In Reply Refer To: HSSD/B-184

This letter is in response to your request for the Federal Highway Administration (FHWA) acceptance of a modification to a Nucor Steel Marion cable barrier for use on the National Highway System (NHS).

Name of system: Nu-Cable System – Extended Hanging Hook
Type of system: Cable Barrier
Test Level: NCHRP Report 350 TL-4
Testing conducted by: Holmes Solutions of New Zealand
Date of request: July 25, 2006

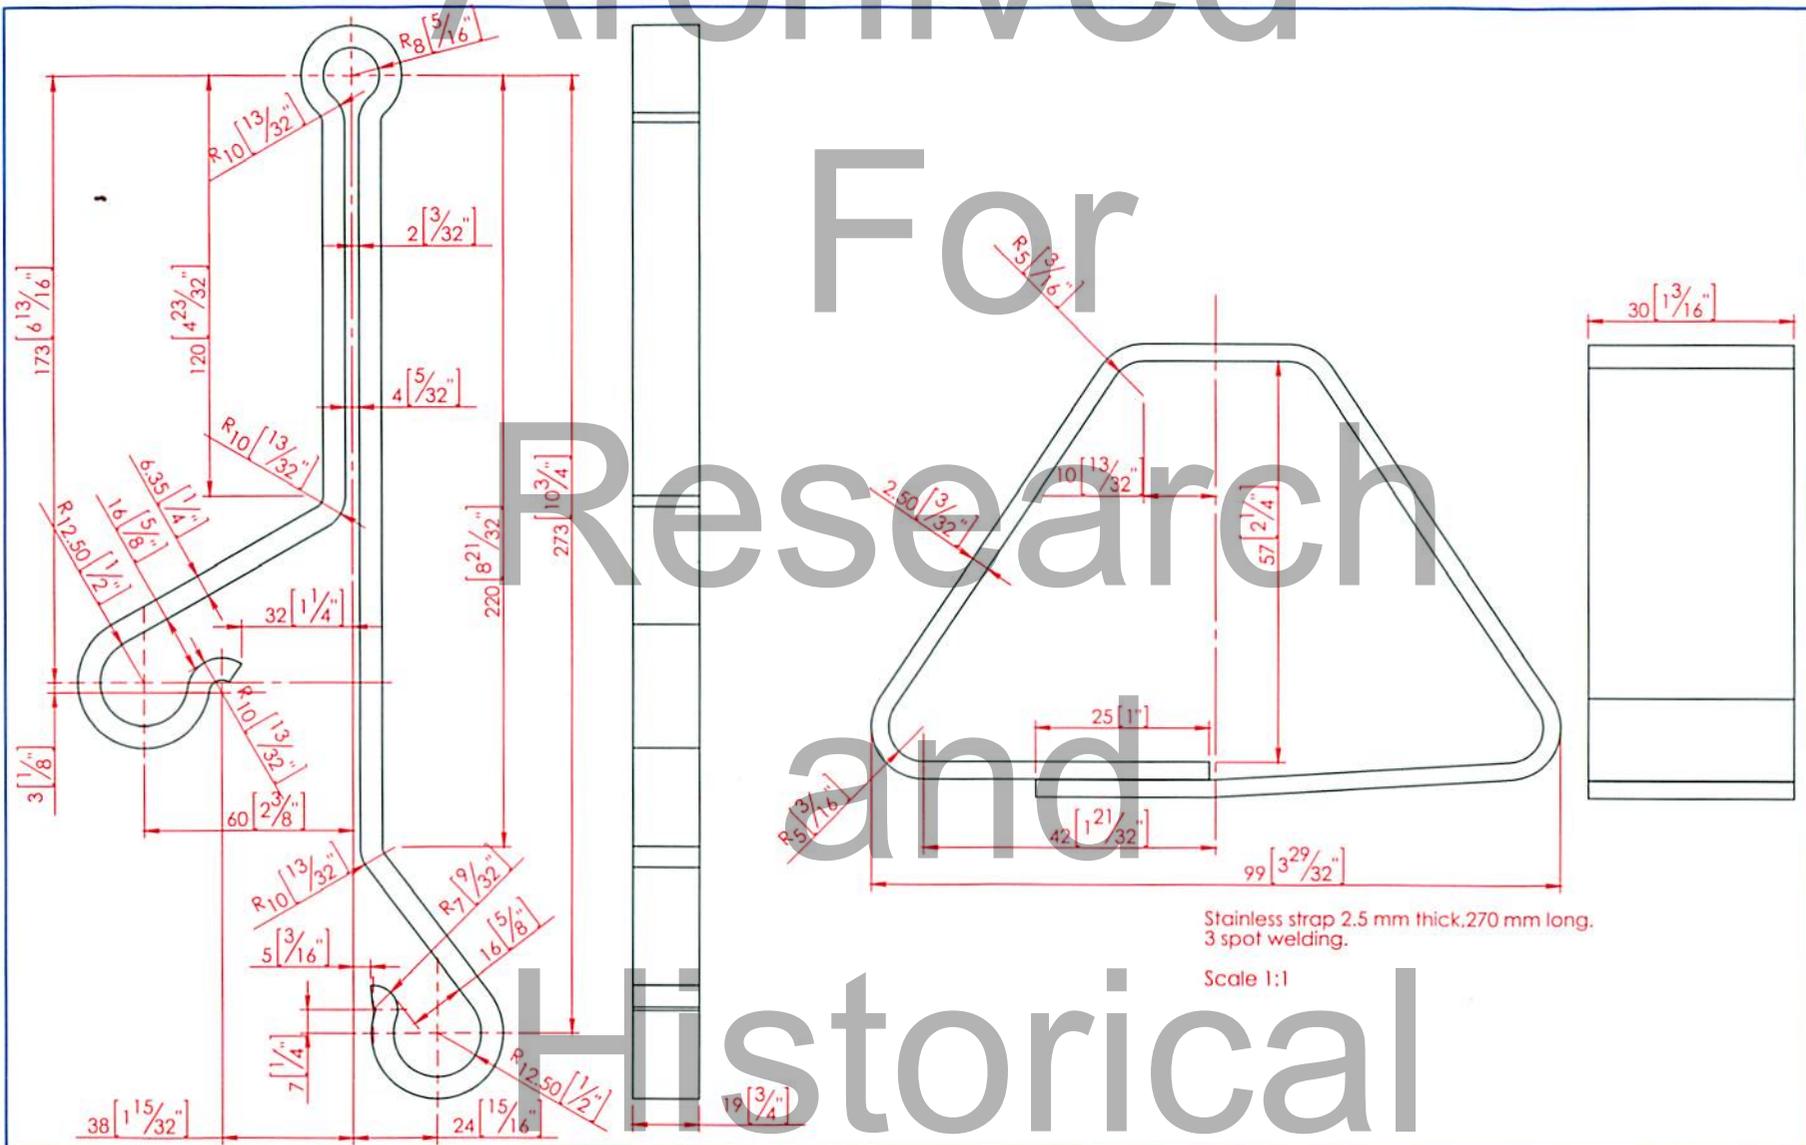
The Nucor Nu-Cable System consists of four 19-mm (3/4-inch) wire rope cables at heights of 380 mm, 640 mm, and two at 890 mm (15 inch, 25 inch, and 35 inch) above ground level. The lower two cables are attached using locking hook bolts which connect directly to the U-posts. The top two cables are supported by a top clip which engages with the top of the U-post section. The original hanging clip held the top two cables at the same height of 890 mm above the ground. Because these two cables are next to each other the barrier appears to have only 3 cables when viewed from a passing vehicle. Your present request is to revise the hanging clip by lowering one of the cables by 100 mm (4 inches.) This will separate the cables so that all four are visible. As the cable on the near-side of the post will remain at 890 mm there should be no change in performance of the barrier under TL-4 conditions.

Therefore, the Nucor Nu-Cable System with the revised hanging clip described above and detailed in the enclosed drawings is acceptable for use on the NHS under the range of conditions tested, when such use is acceptable to a highway agency.
